City of Corpus Christi

1201 Leopard Street
Corpus Christi, TX 78401
cctexas.com

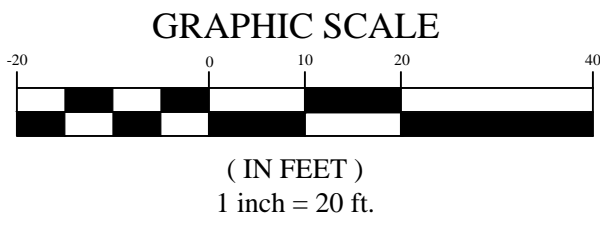
Comment ID	Author : Department	Status	Review Comments	Applicant Response Comments
15	Alex Harmon : DS	Closed	Improvements Required for Recordation, per UDC 8.1.4. A. Streets: No, see separate comment about bike blvd. Sidewalks: No, per 8.2.2 B. Water: No Fire hydrants: No C. Wastewater: No D. Stormwater: No E. Public open space: No F. Permanent monument markers: No Please note, improvements required should be constructed to city standards, found in Article 8 and the IDM.
